KEWAUNEE NUCLEAR POWER PLANT  
DOCKET 50-305  
LICENSE No. DPR-43  
LICENSE AMENDMENT REQUEST 187 TO THE KEWAUNEE NUCLEAR POWER PLANT  
TECHNICAL SPECIFICATIONS (TAC NO. MB5718)

Enclosure-RAI Question 58 Response

Figure 58-1: Peak Cladding Temperature Comparison

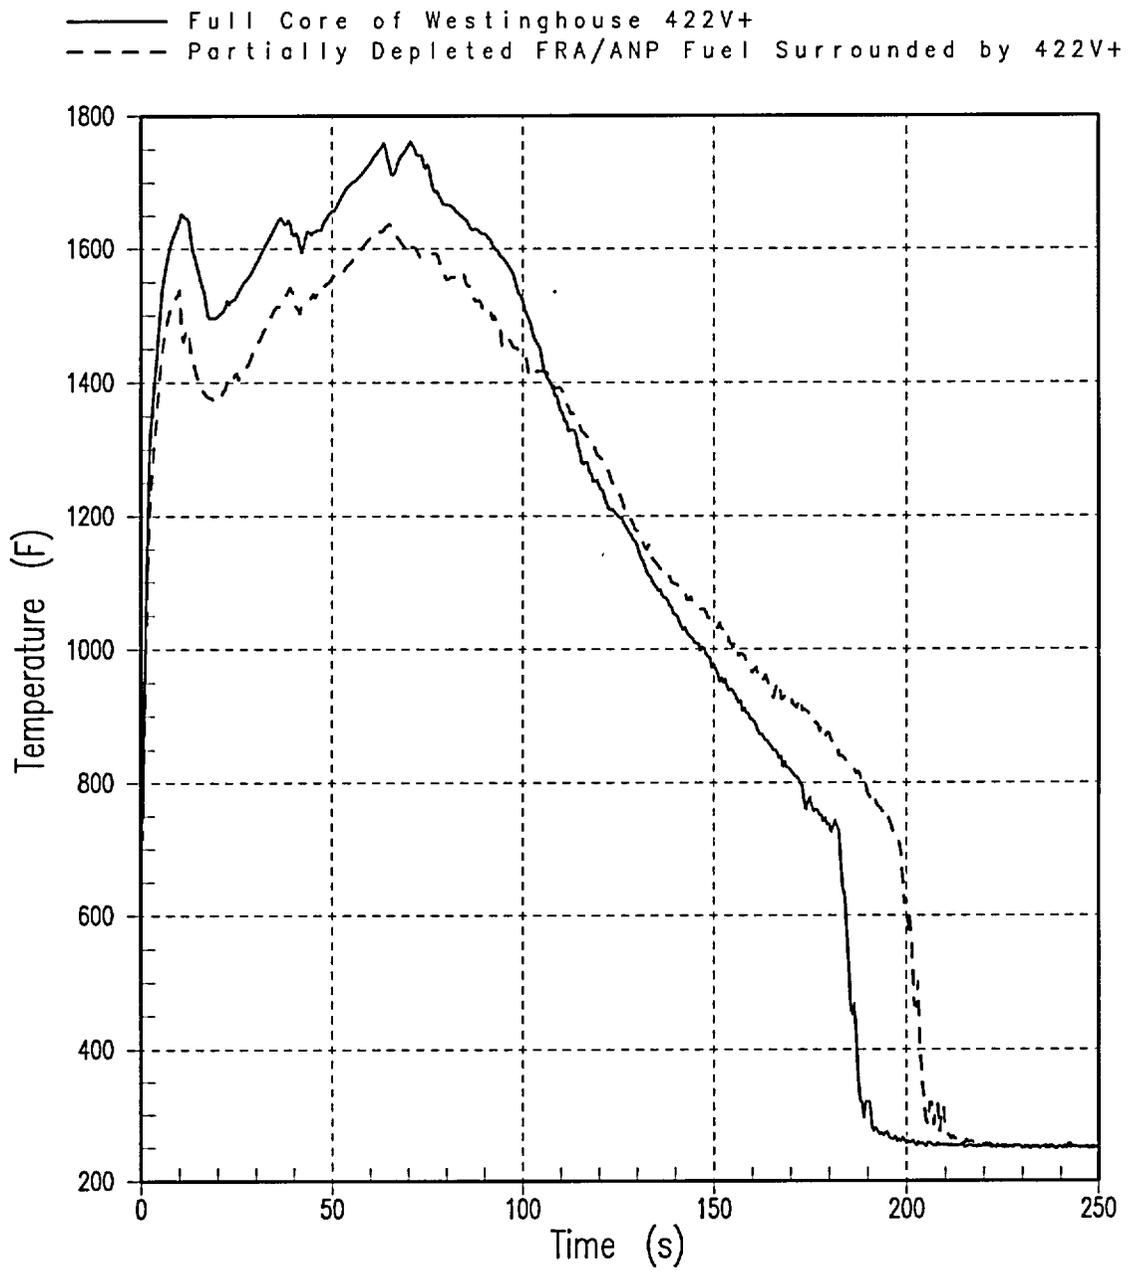
58. Because it is possible for one fuel type to be PCT-limiting, and another to be oxidation-limiting, provide a commitment to report LOCA analysis results for all fuel types (represented in a significant number of assemblies), per 10 CFR 50.46 (a)(3).

Figure 58-1 shows the PCT transients for a full core of 422V+ fuel compared to a transition core with partially depleted Framatome ANP fuel surrounded by 422V+ fuel. This calculation was performed using the reference transient conditions as defined by the Westinghouse methodology in WCAP-14449-P-A. Figures 58-2 and 58-3 compare the RCS pressure transients for those two runs, for the entire transient, and for the reflood portion, respectively. Figure 58-4 compares the hot assembly collapsed liquid level. It can be seen that the core configuration has little effect on the RCS pressure or hot assembly collapsed liquid level. The reflood PCTs from Figure 58-1 are 1763°F for the full core 422V+ fuel calculation, and 1638°F for the calculation with partially depleted Framatome ANP fuel surrounded by 422V+ fuel.
